10/729,197
December 27th, 2004
Reply to Office Action of 09/27/2004

Remarks

10/729,197
December 27th, 2004
Reply to Office Action of 09/27/2004
Annotated Sheet Showing Changes

FIG. 1

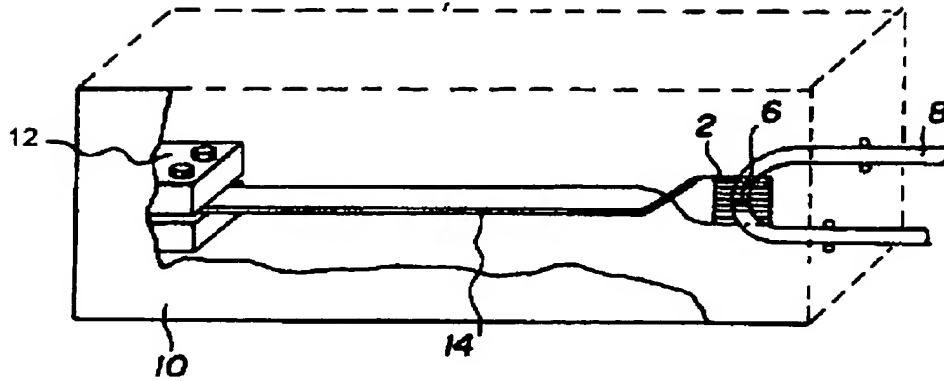
In regards to a prior art label on figure 4, this has been added.

← "PRIOR ART"
ADDED
